Project	IEEE 802.20 Working Group on Mobile Broadband Wireless Access	
	http://grouper.ieee.org/groups/802/20	
Title	Requirements: Selected topics, including MAC+PHY aggregate capacity	
Date Submitted	2003-07-17	
Source(s)	Marianna Goldhammer Tel Aviv, HaBarzel 21 Israel	Voice: +972 3 645 6241 Fax: Email: marianna.goldhammer@alvarion.com
Re:	MBWA Call for Contributions 802.20-03/09	
Abstract		
Purpose	The scope of this contribution is to improve the 802.20 Requirement document, Ver. 3.	
Notice	This document has been prepared to assist the IEEE 802.20 Working Group. It is offered as a basis for discussion and is not binding on the contributing individual(s) or organization(s). The material in this document is subject to change in form and content after further study. The contributor(s) reserve(s) the right to add, amend or withdraw material contained herein.	
Release	The contributor grants a free, irrevocable license to the IEEE to incorporate material contained in this contribution, and any modifications thereof, in the creation of an IEEE Standards publication; to copyright in the IEEE's name any IEEE Standards publication even though it may include portions of this contribution;

1 **Figure 1—802.20 protocol layering, showing service access points (SAPs)**

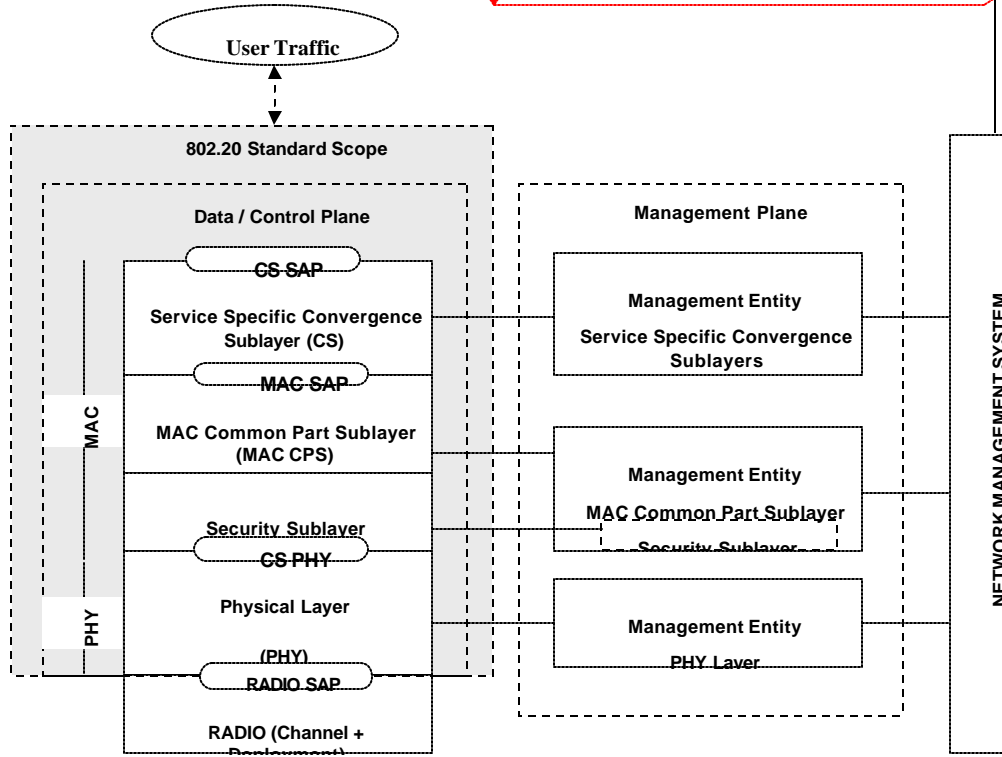
2. It is proposed an 802.20 Reference Model, access specific instead of WLAN specific.
3. The Version 3 of the document provides a fairly good system description, but not emphasizes enough PHY and MAC protocol requirements. As consequence, there is some confusion area between product requirements, system requirements and PHY-MAC requirements. This contribution proposes numerical performance targets (as resulting from 802.16d/e drafts), specific for PHY+MAC interface to upper layers. For simplicity sake, the performance targets are defined as function of payload size, rather than specific services, and are given at specific modulations and coding overheads, speeds and cell sizes.

21 To aid the discussion in this document and in the 802.20 specifications, a straw man Reference
22 Partitioning of the 802.20 functionality is shown in Figure 1. This reference partitioning model is
23 similar to those used in other 802 groups.

24 The 802.20 reference model consists of two major functional layers, the Data Link Layer
25 (DLL) and the Physical Layer (PHY).

27 The MAC comprises three sublayers. The Service Specific Convergence Sublayer (CS)
28 provides any transformation or mapping of external network data, received through the CS
29 service access point (SAP), into MAC SDUs (Service Data Unit) received by the MAC
30 Common Part Sublayer (MAC CPS) through the MAC SAP. This includes classifying external
31 network SDUs and associating them to the proper MAC service flow and Con-nection ID. It
32 may also include such functions as payload header suppression. Multiple CS specifications are
33 provided for interfacing with various protocols. The internal format of the CS payload is unique
34 to the CS, and the MAC CPS is not required to understand the format of or parse any
35 information from the CS payload.
36 The MAC Common Part Sublayer (CPS) provides the core MAC functionality of system
37 access, bandwidth allocation, connection establishment, and connection maintenance. It receives

- 1 data from the various CSs, through the MAC SAP, classified to particular MAC connections.
- 2 QoS is applied to the transmission and scheduling of data over the physical layer.
- 3 The MAC also contains a separate Security Sublayer providing authentication, secure key
- 4 exchange, and encryption.
- 5 Data, physical layer control, and statistics are transferred between the MAC CPS and the
- 6 physical layer (PHY) via the PHY SAP.

Deleted: Figure 1 – Reference partitioning¶

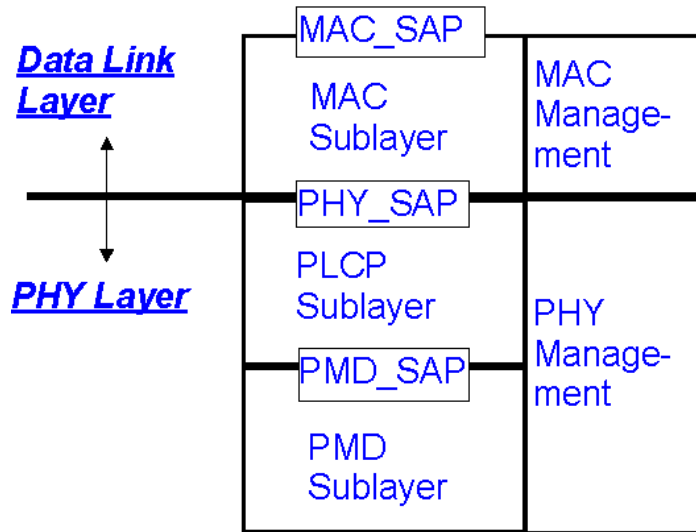
Deleted: The Data Link Layer is functionally responsible for a mobile station's method of gaining access to the over-the-air resource. The Data Link Layer consists of the MAC Sub layer, and the MAC Management Sub layer. The MAC Sub layer is responsible for the proper formatting of data, as well as requesting access to the over-the-air resource. The MAC Management Sub layer is responsible for provisioning of MAC Layer Parameters and the extraction of MAC monitoring information, which can be of use in network management. ¶
 The Physical Layer consists of the Physical Layer Convergence Protocol, the Physical Medium Dependent, and the Physical Layer Management Sub layers. The Physical Layer Convergence Protocol Sub layer is responsible for the formatting of data received from the MAC Sub layer into data objects suitable for over the air transmission, and for the deformatting of data received by the station. The Physical Medium Dependent Sub layer is responsible for the transmission and reception of data to/from the over-the-air resource. The Physical Layer Management sub layer is responsible for provisioning of the Physical Layer parameters, and for the extraction of PHY monitoring information that can be of use in network management. ¶
